City of Plymouth Planning Commission

Regular Meeting Agenda

Wednesday, March 13, 2024 – 7:00 p.m.
City Hall & Online Zoom Webinar

**Special Land Use and
Site Plan Review
For
Plymouth, Michigan**

SHEET NUMBER: **ST1.1**

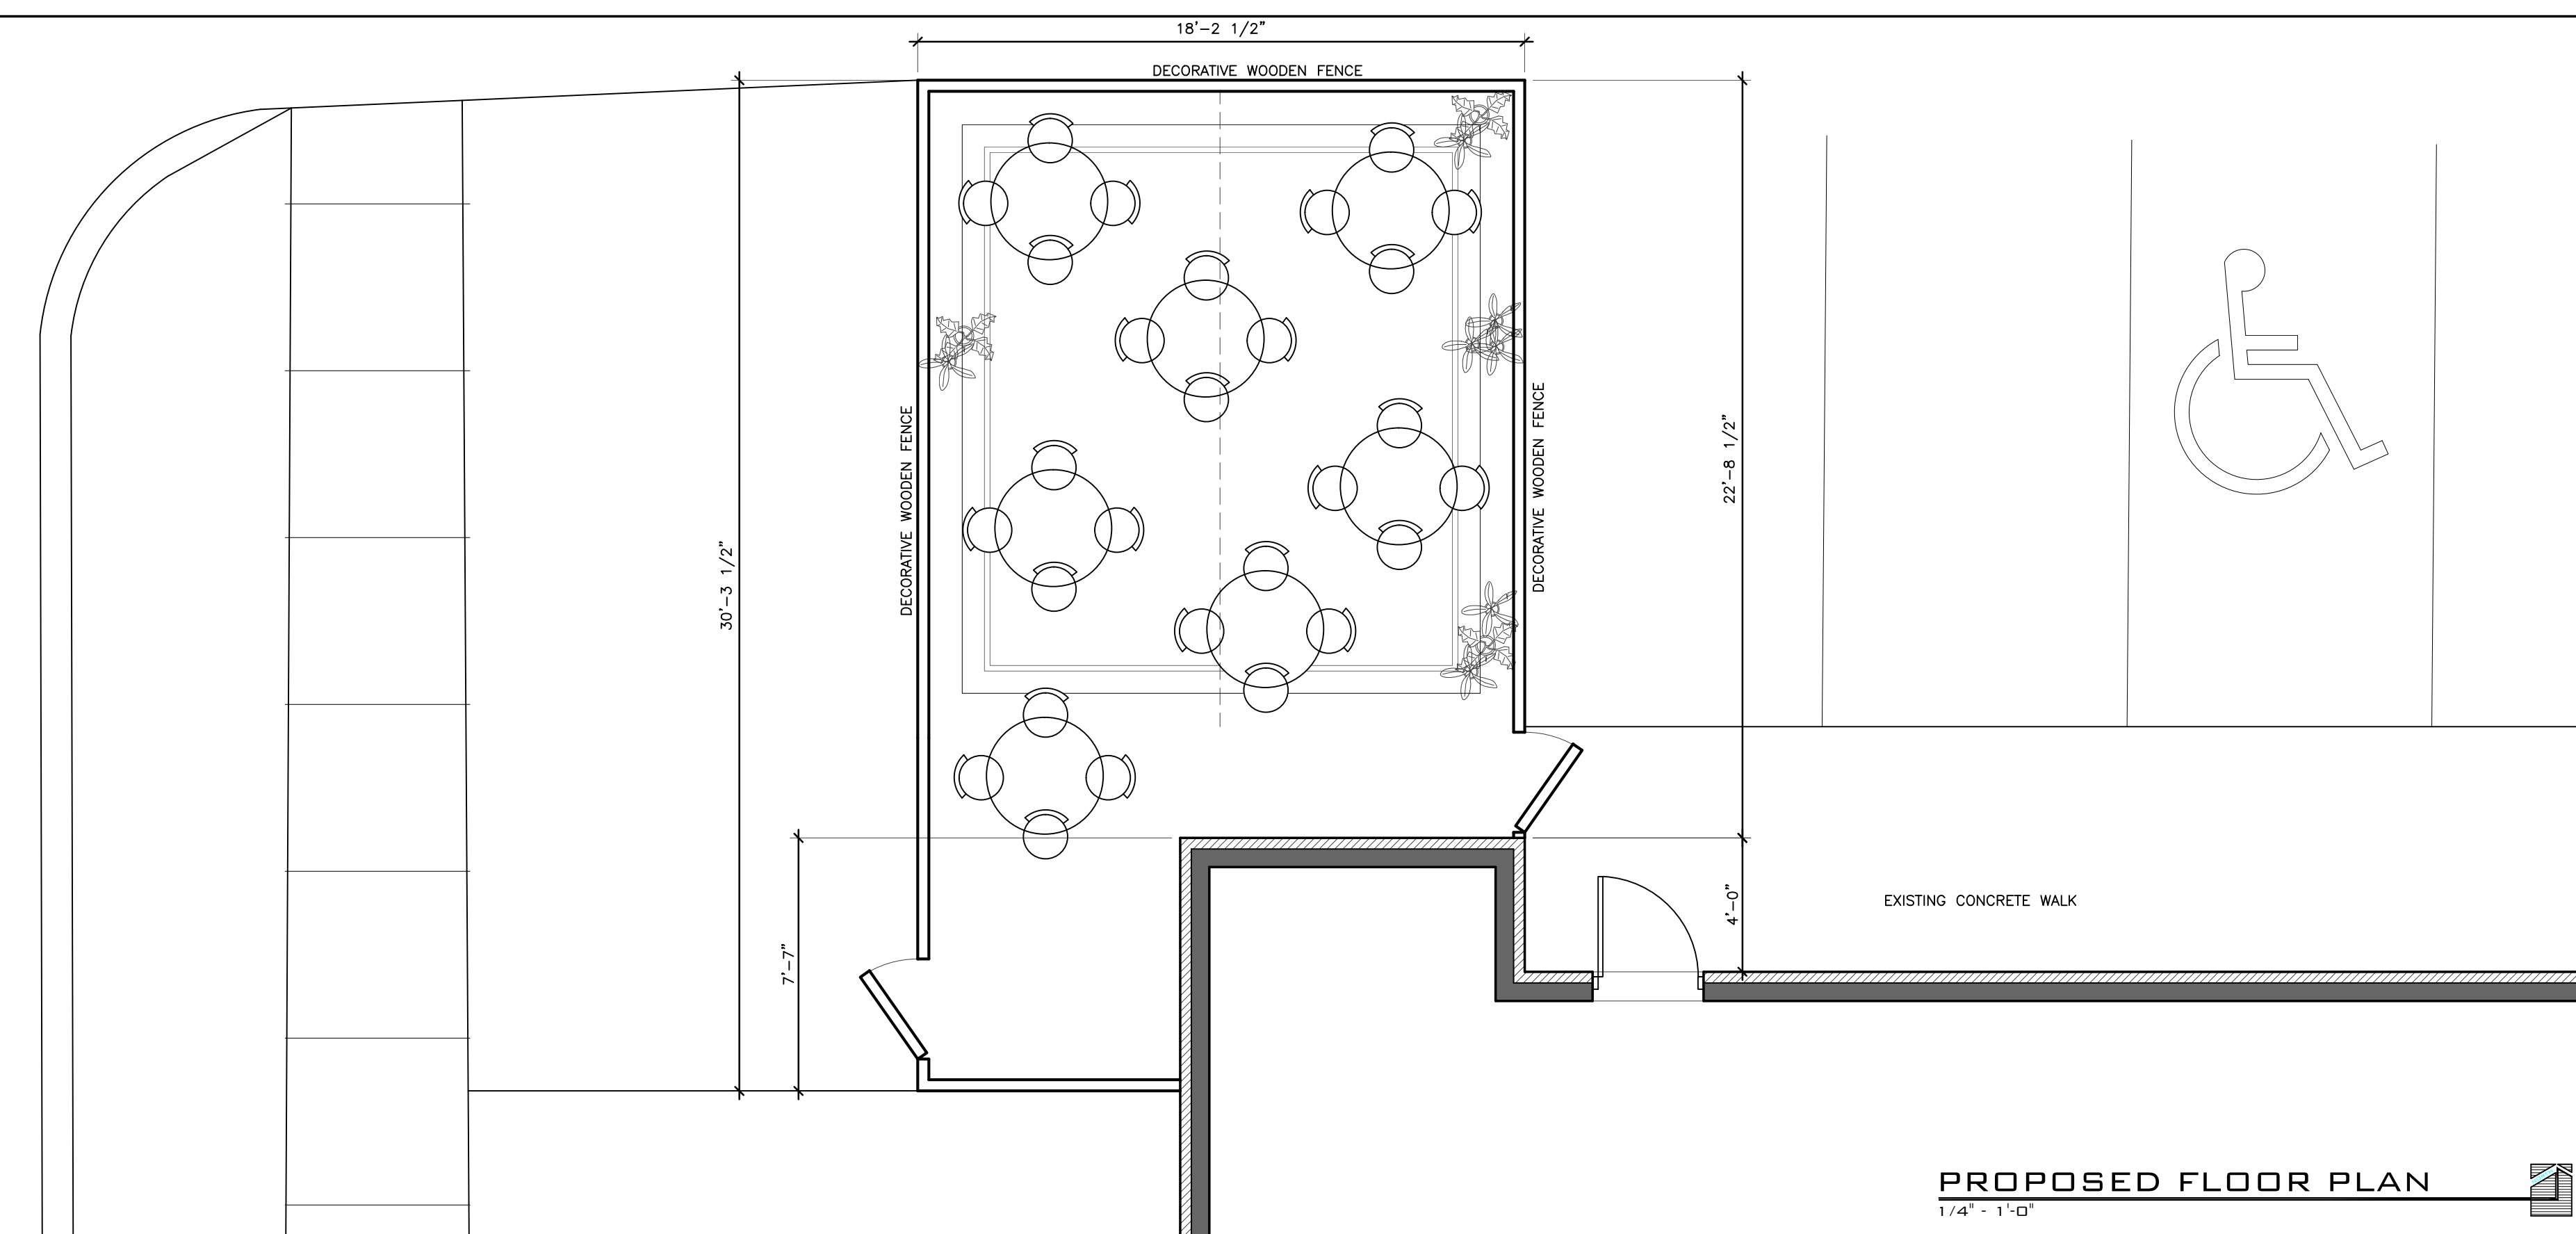
The plans do not accurately reflect the existing conditions on site. The building is much closer to the public sidewalk on both Starkweather and N. Main St. than the plans indicate. The location of the building on site needs to be corrected.

The outdoor dining area is proposed to be located in the two most westerly parking spaces on the north side of the building. The plan shows a 14-foot wide strip of asphalt between the sidewalk

and proposed edge of the outdoor dining fence; however, this space is actually only about 4-feet wide, which is within the right-of-way. The proposed dining use should not be placed in the right-of-way. To make the proposal more consistent with the goals of the Master Plan, the Planning Commission may want to discuss the addition of landscape planters along the west side of the dining enclosure fence.

No permanent structures are proposed. Sheet ST1.1 shows photographs of when an outdoor dining area was installed up next to the sidewalk in previous years, with a black fence. Will the same fence/umbrellas/chairs shown in the photos be used if the outdoor dining area is approved? The plans also show that the outdoor dining area will accommodate 7 tables/28 patrons.

Per Section 78-247, the submission shall show specific site information. A site layout, including the building to the north, is provided on Sheet ST1.1. We have the following comments:

- 1) The building to the north is not on the subject site, but on an independent lot. The site plan should show the property line that divides the subject site from the lot to the north.
- 2) The aerial photograph of the existing building (captured in 2023) shows the edge of the building about 5-feet from the edge of the public sidewalk along N. Main St. The site plan locates the edge

of the building approximately 26-feet from the edge of the public sidewalk along N. Main St. Another inconsistency is that the aerial photo doesn't show a sidewalk on the east side of the building (while the site plan shows this walk). Is the applicant proposing to add a sidewalk here, and extend this walk south to connect to the public walk along Main St.? The southern-most driveway into the parking lot along Starkweather is located approximately 105 feet from N. Main St.; the site plan shows the driveway approximately 130 feet from N. Main St. The site plan must be drawn on an accurate survey of the property. The submission needs to be corrected and resubmitted.

- 2) Does the "maximum occupancy" figure include the roofed/enclosed dining area that was added to the west side of the building? If not, it should be added.
- 3) The number of spaces shown on the site plan are inconsistent with the aerial photograph (captured in 2023), as follows:
 - a. Parking spaces adjacent to the east side of the restaurant building: aerial shows 6 spaces; site plan shows 5 spaces.
 - b. Parking spaces adjacent to the north side of the restaurant building: aerial shows 7 spaces (of which 2 are being occupied by the proposed outdoor dining area), but the location of these spaces is not consistent with the aerial.
 - c. Parking spaces in the middle of the lot: aerial shows 11 spaces in the same location as the site plan shows 10 spaces (although the arrow indicating the 10 spaces should extend all the way to the Starkweather public sidewalk to count 10 spaces).

- d. Parking spaces on the east side of the neighboring building to the north: aerial shows 3 spaces with a shed occupying the most northerly spaces; site plan shows 5 spaces and doesn't show the shed.

Items to be Addressed: 1) *Site Plan should be drawn on an accurate survey of the property; the plan should be corrected and resubmitted.* 2) *Is the applicant proposing to locate a new sidewalk on the east side of the building, and extend this walk to the public walk on N. Main St.?*

Items to be Addressed: 1) Correct plans to reflect the existing number of parking spaces, and accurately located on the site. 2) Provide floor plans of the existing building so that the floor area figures and maximum occupancy on the plans can be confirmed. 3) Defer determination if parking is required for outdoor dining to Community Development Director. 4) Applicant to provide shared parking agreement with northern property owner to the City as part of the Special Land Use request.

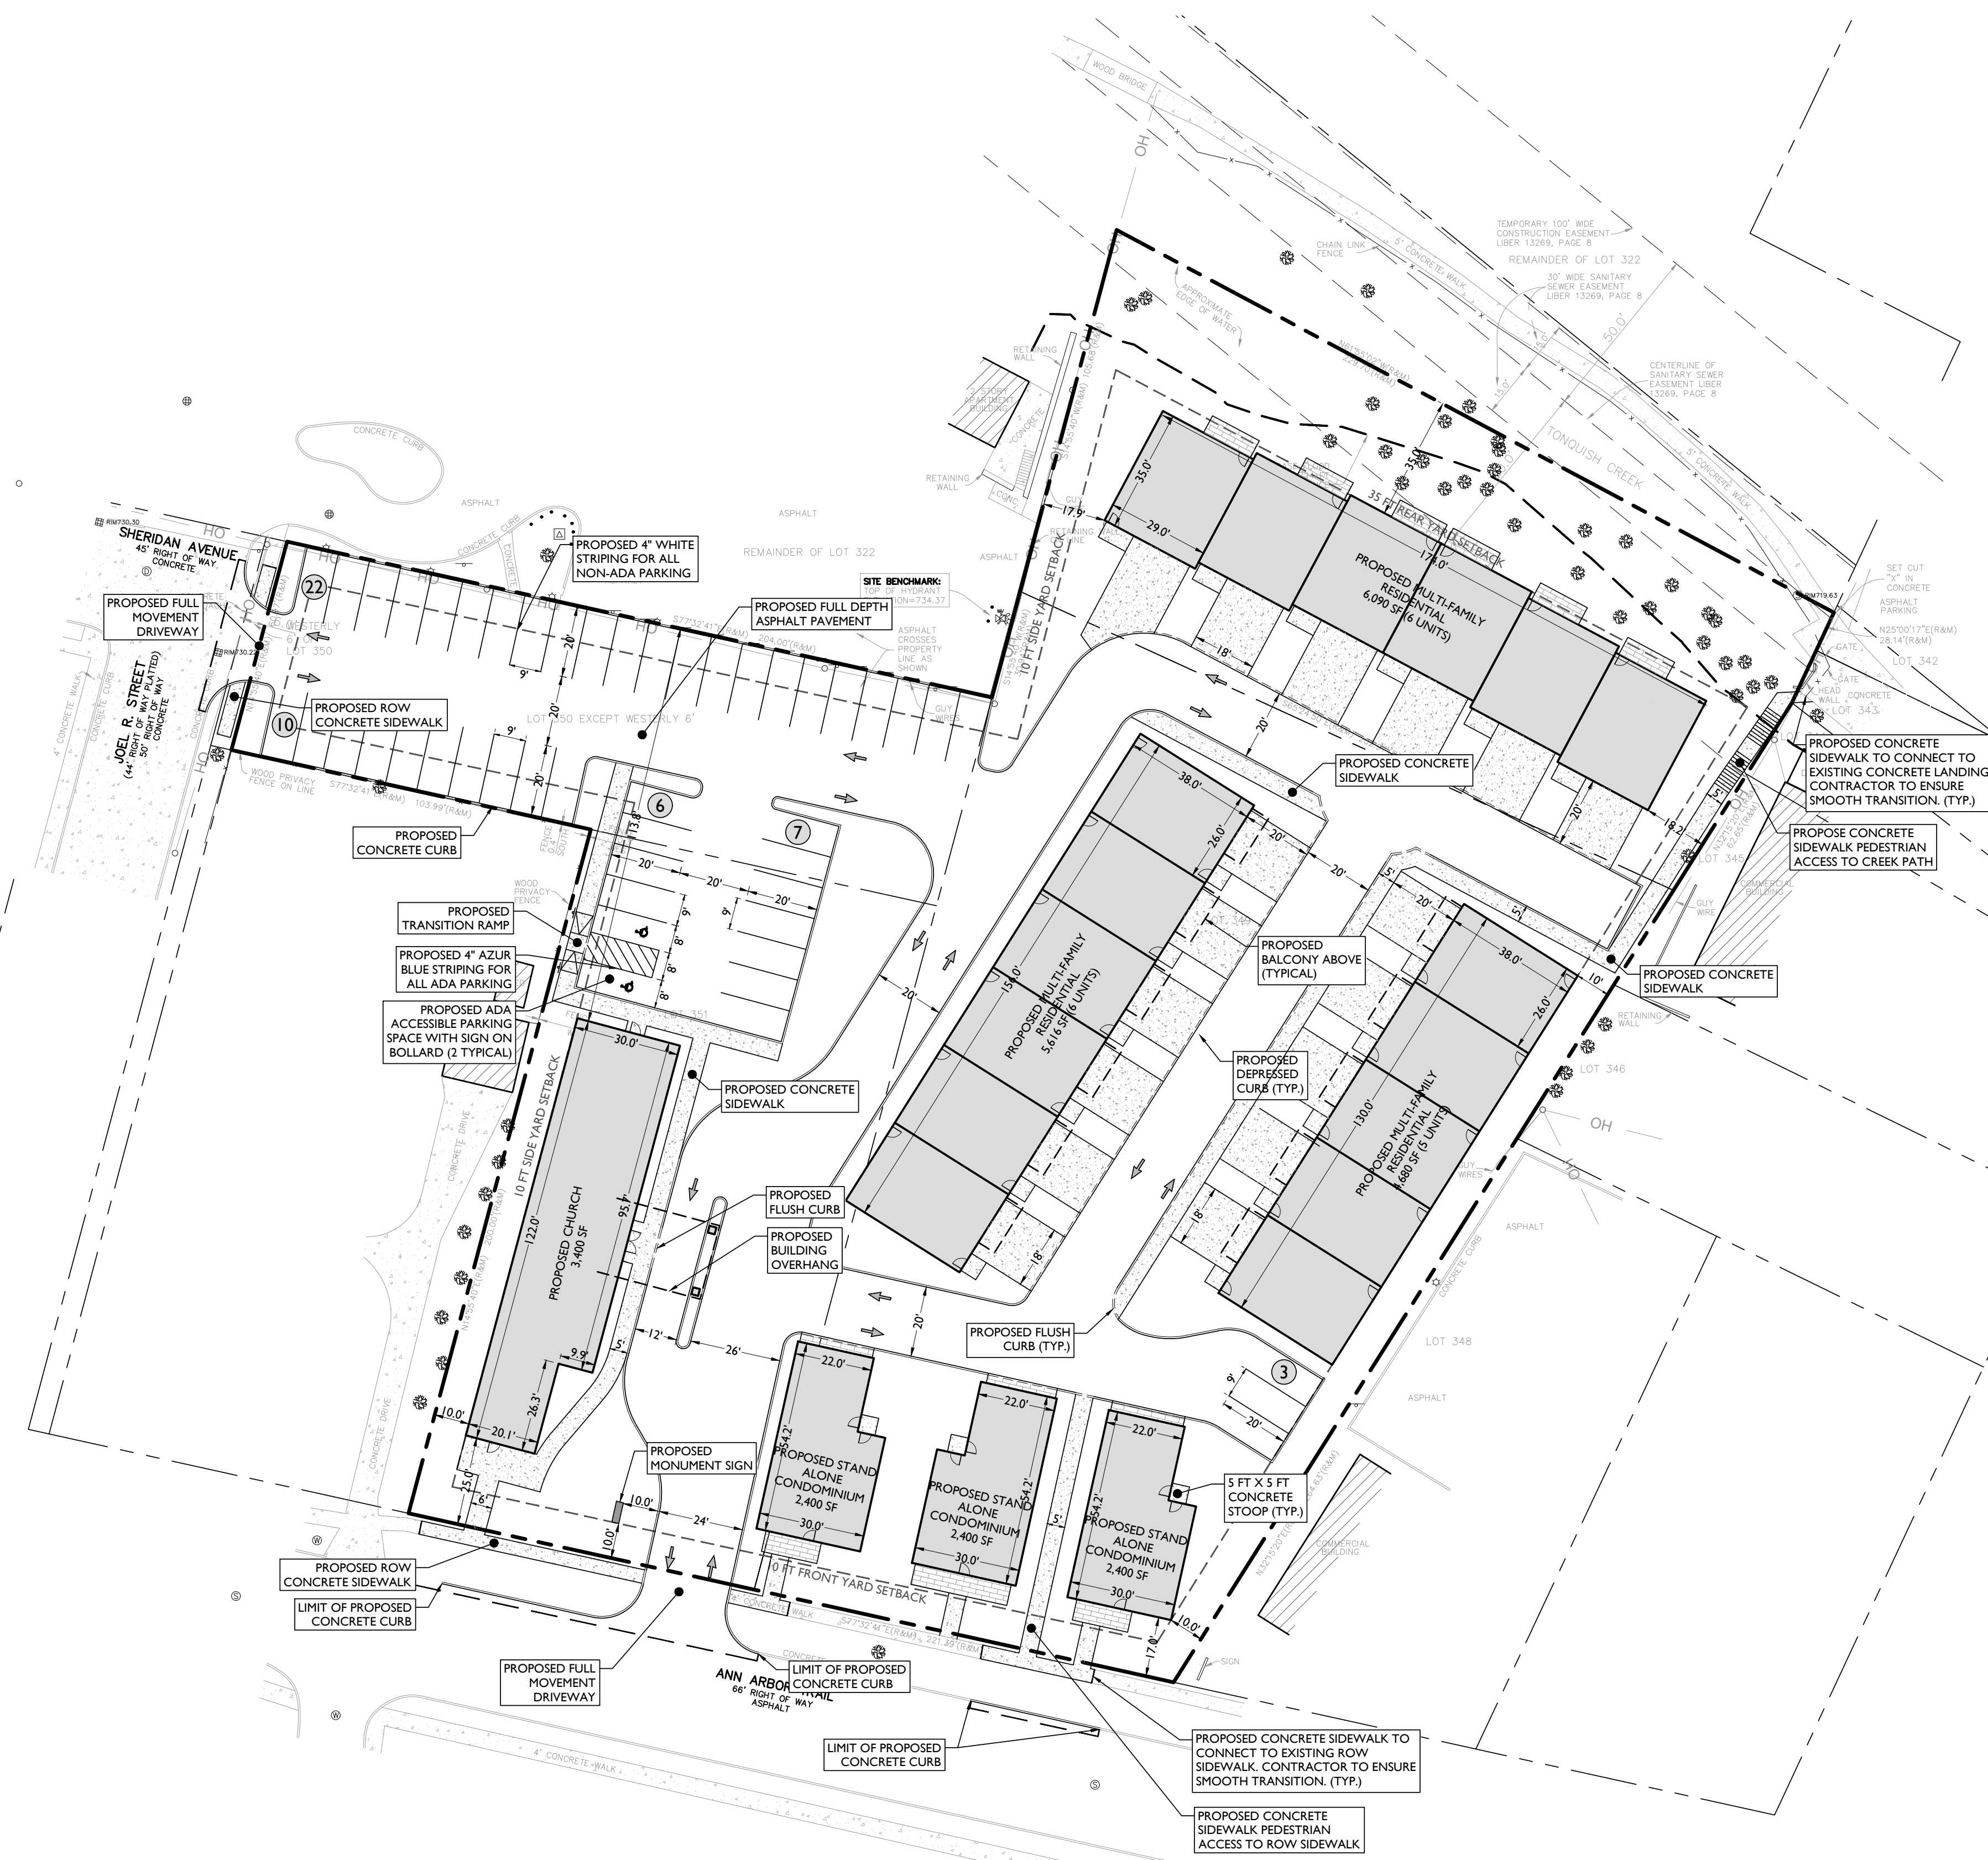
- vi. **Construct a new access stair at the head end of the Creek.** This proposal is shown on Sheet C-3, showing these stairs as part of an internal sidewalk system, and a connection to the public sidewalk between two of the individual condo units along Ann Arbor Trail. This connection will benefit project residents and the public at large. To accomplish this benefit, the end of the staircase will need a section of pavement located on the easterly neighbor’s property (and therefore an easement) to meet up with the trail. Has the applicant discussed this with the neighboring property owner?
